AWNING ADAPTER

Bulletin Type:	Technical Service Bulletin TSB	Publication Date:	August 2020
Bulletin #(s):	20-018	Make(s):	Entegra Coach
Job Code(s):	9801512	Model(s):	Aspire, Anthem, Cornerstone
Flat Rate(s):	.5 Hour	Model Year:	2020

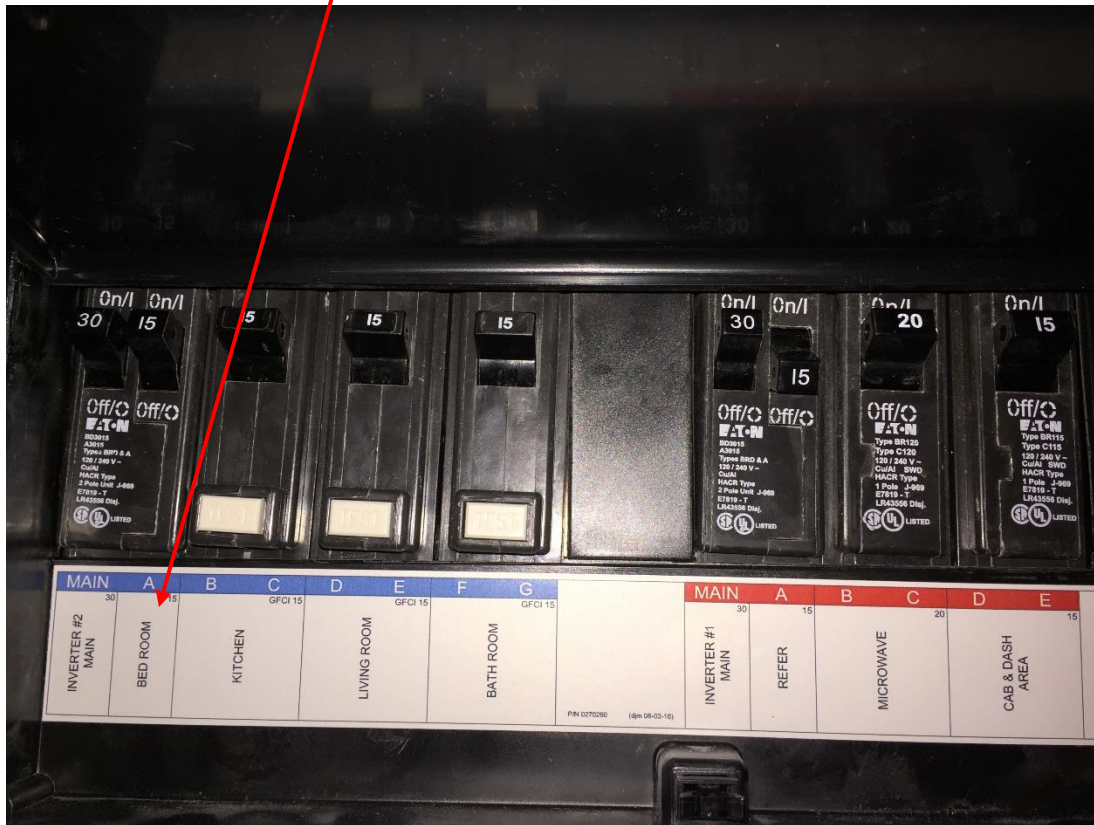
Incident:	The Girard awning may retract when various interior lights are operating.
Affected Units:	Please see the serial number listing at end of the repair instructions.
Parts Kit:	Kit #: 20-018E
	Contents: 2- Pigtail, Sensor motion w/Capacitor (1 per awning) 2 – wire ties (1 per awning)

Below shows, the in-line capacitor and zip tie to install to each of the Girard awnings (2). Awnings are located on the passenger side of the motorhome.

5. Install the in-line Capacitor between the sensor and harness. (it can only go one way)

6. Secure wiring with zip tie. Be sure the wires are located, to prevent damage when awning is retracted.
7. Repeat installation steps 3-6 adding the in-line capacitor to the second awning.
